RE: Docket ID No. EPA-HQ-SFUND-2015-0139
NPL Listing Proposal for Anaconda Aluminum Co. Columbia Falls Reduction Plant: Comments of Atlantic Richfield Company

TECHNICAL REPORT

SUBJECT: Review of the Columbia Falls Aluminum Company, LLC (CFAC), HRS Documentation Record

FIGURE 1

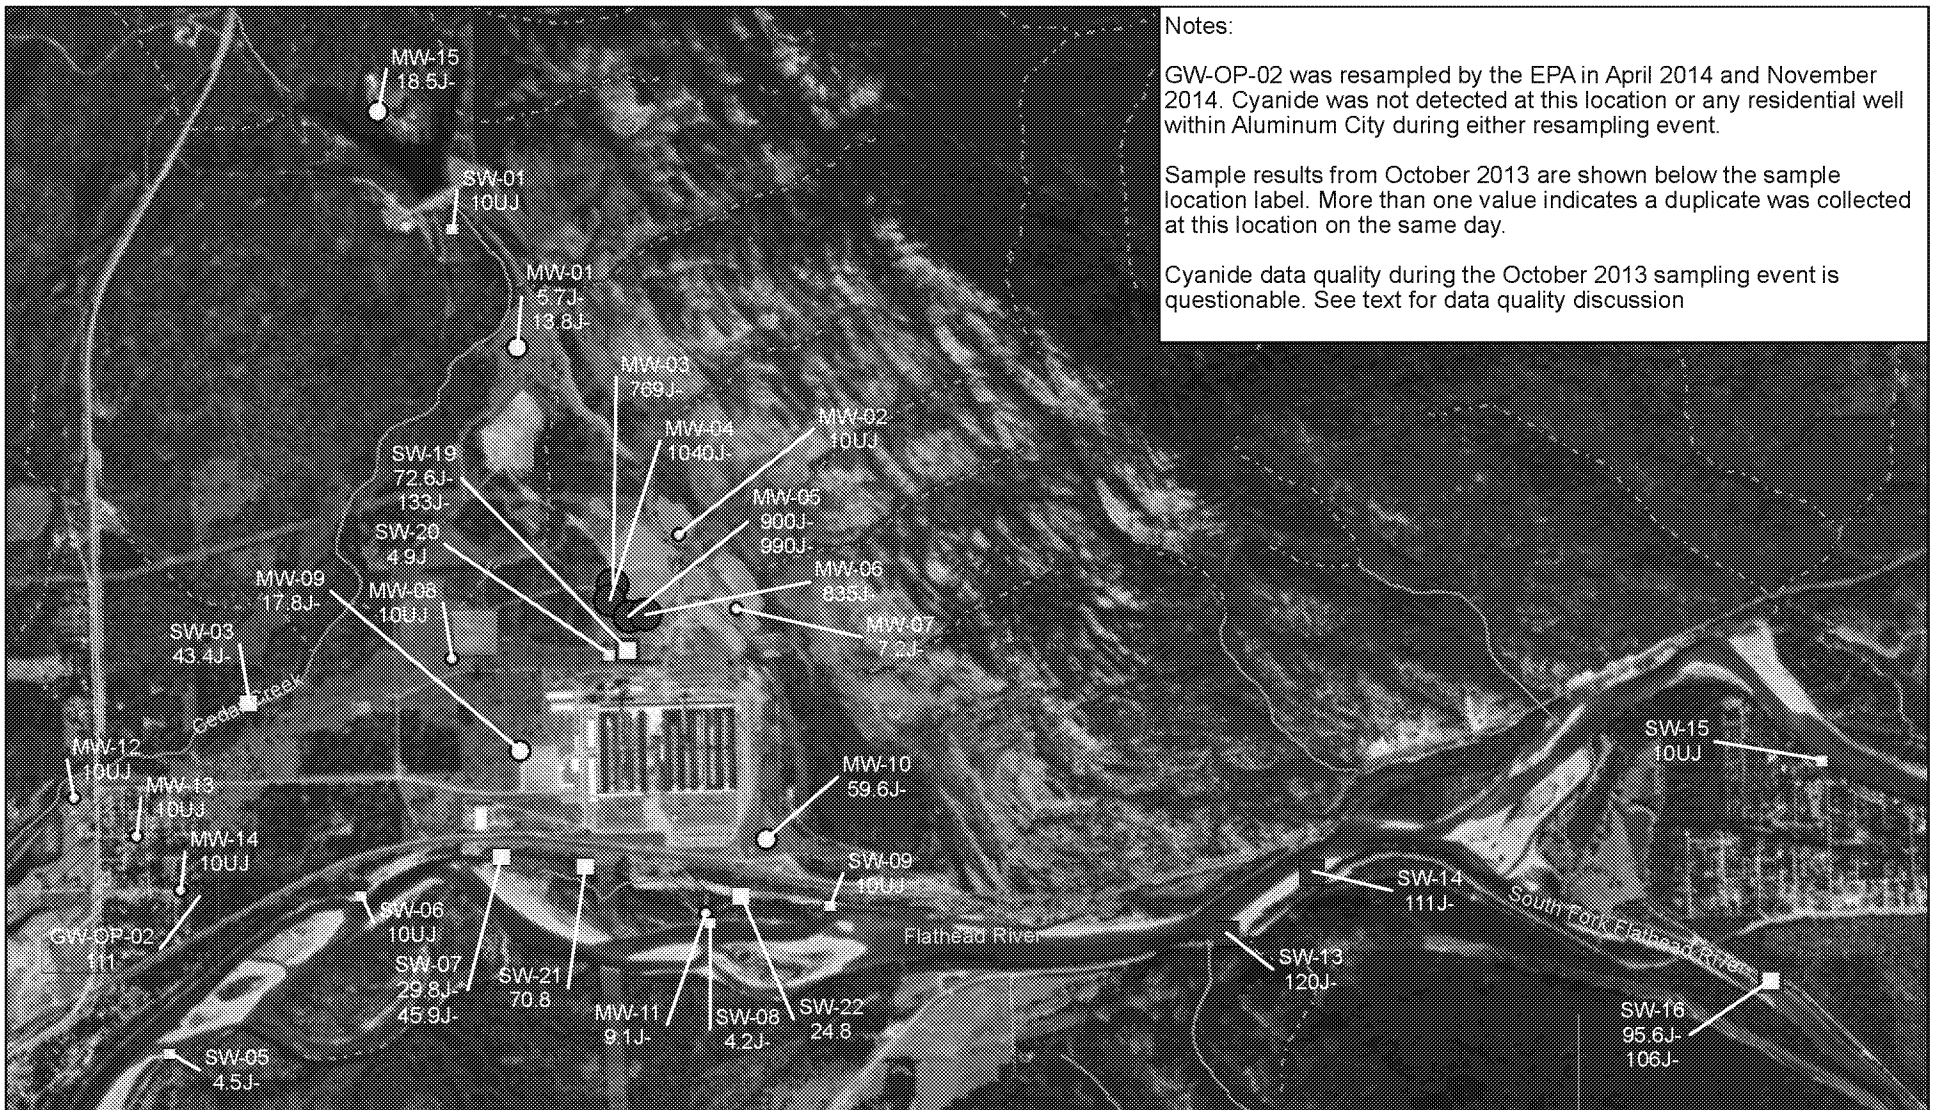
As shown on attached Figure 1, Cyanide was also detected in the background samples in the Flathead River (SW-13 at 120 ug/L, SW-14 at 111 ug/L, and SW-16 at 96-106 ug/L) upstream of the Site at concentrations significantly greater than Flathead River samples below the Site (SW-06 at <10 ug/L and SW-05 at 4.5 ug/L). Cyanide was also detected in the background groundwater upgradient of the Site above Cedar Creek Reservoir (MW-01 at 18.5 ug/L). If cyanide was migrating from the West Landfill through the alluvial aquifer, it is reasonable to expect intermediate cyanide concentrations along the groundwater flow path and in adjacent monitoring wells to the residential well where cyanide was detected; yet, this was not the case based on the available analytical results. The monitoring wells along the potential groundwater flow paths (MW-08 and MW-09) from the West Landfill had cyanide concentrations less than the background well (MW-15) and the monitoring wells adjacent to the residential well did not have detectable concentrations of cyanide.

GW-OP-02 was resampled by the EPA in April 2014 and November 2014. Cyanide was not detected at this location or any residential well within Aluminum City during either resampling event.

Cyanide data quality during the October 2013 sampling event is questionable. See text for data quality discussion

FIGURE 2

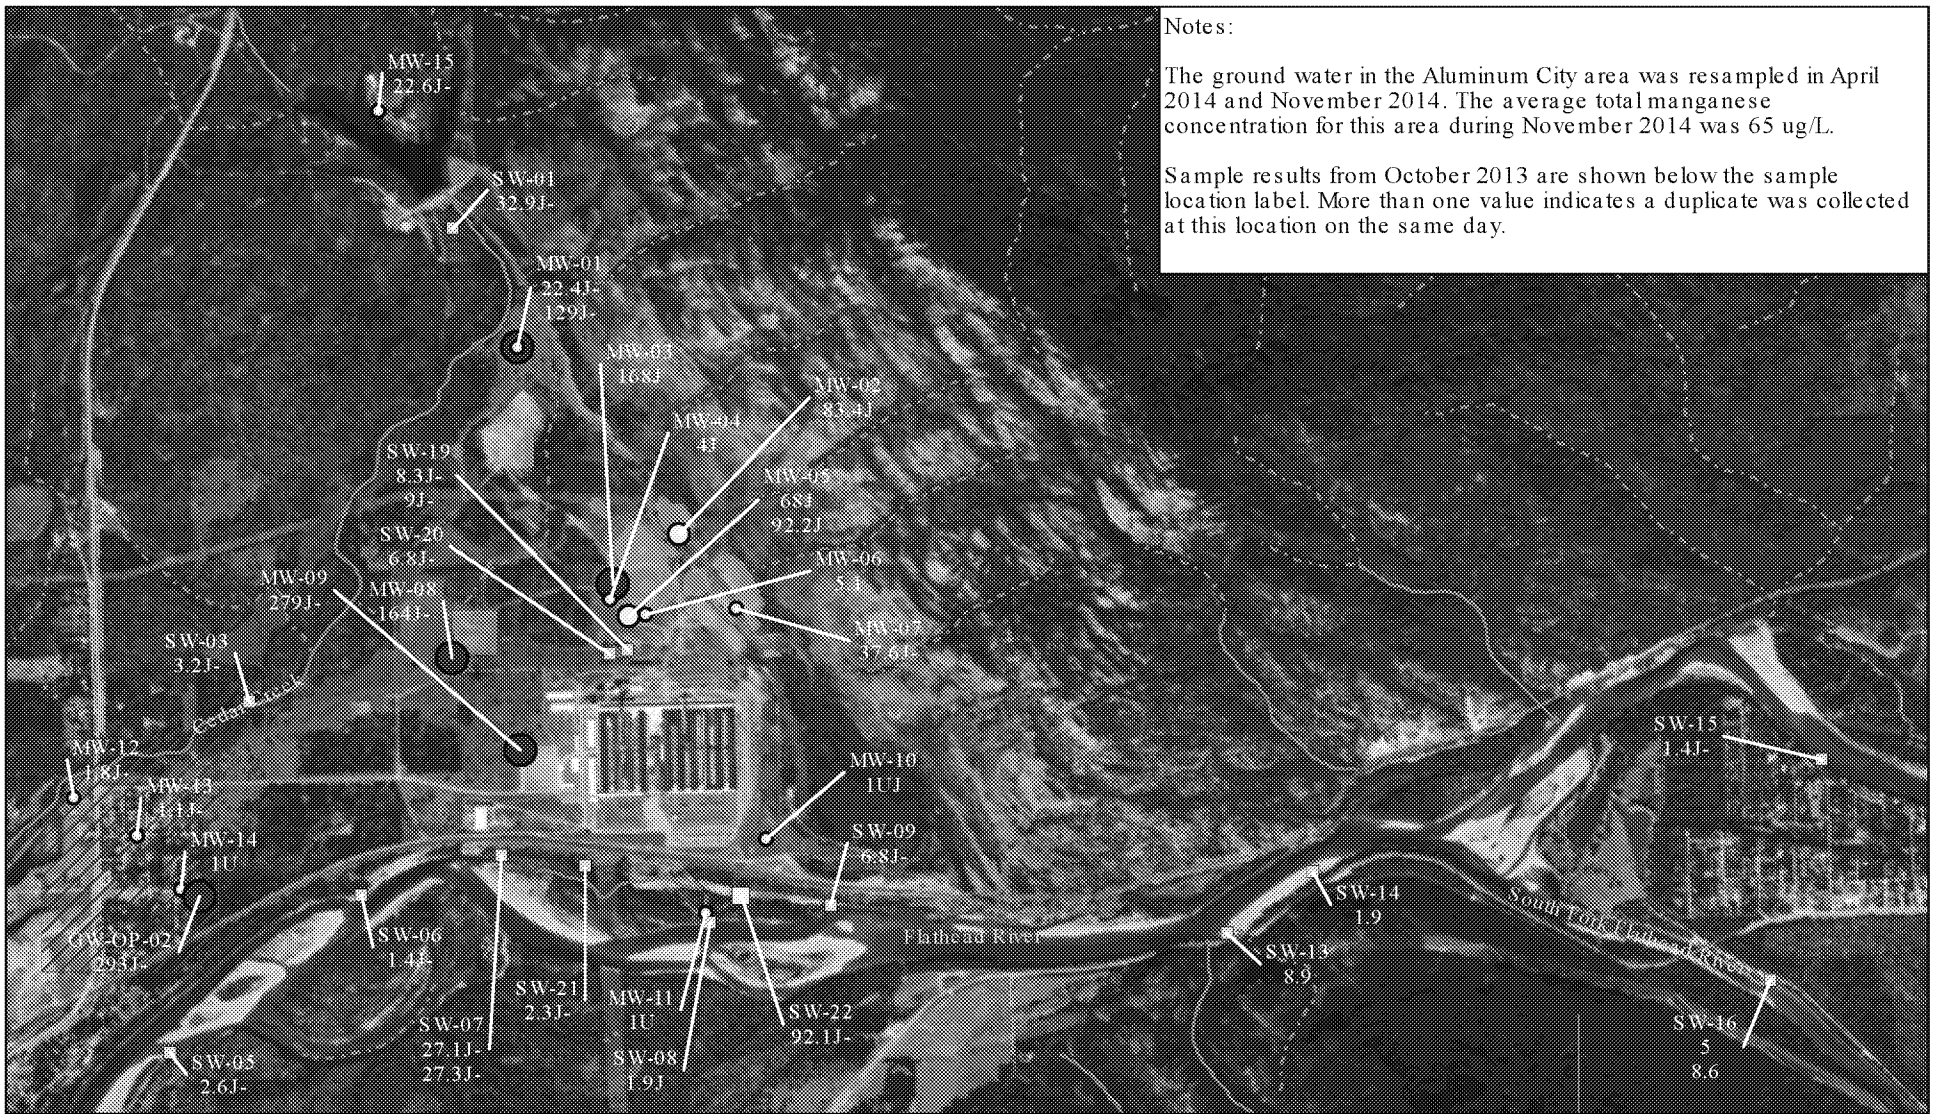
Additionally, as shown on attached Figure 2, the total manganese concentration at this location (CF-SW-07) was less than the Cedar Creek background sample (SW-01 @ 32.9 ug/L) and less than the average groundwater background concentration upgradient from the Site (CF-GW-MW-01 @ 75.7 ug/L). It is reasonable to assume that the CF-SW-07 sample is comprised of a significant amount of alluvial groundwater discharging to this backwatered area of the Flathead River and the results from CF-SW-07 should not only be compared to the Flathead River background samples, but also the alluvial groundwater background samples.

The ground water in the Aluminum City area was resampled in April 2014 and November 2014. The average total manganese concentration for this area during November 2014 was 65 ug/L.
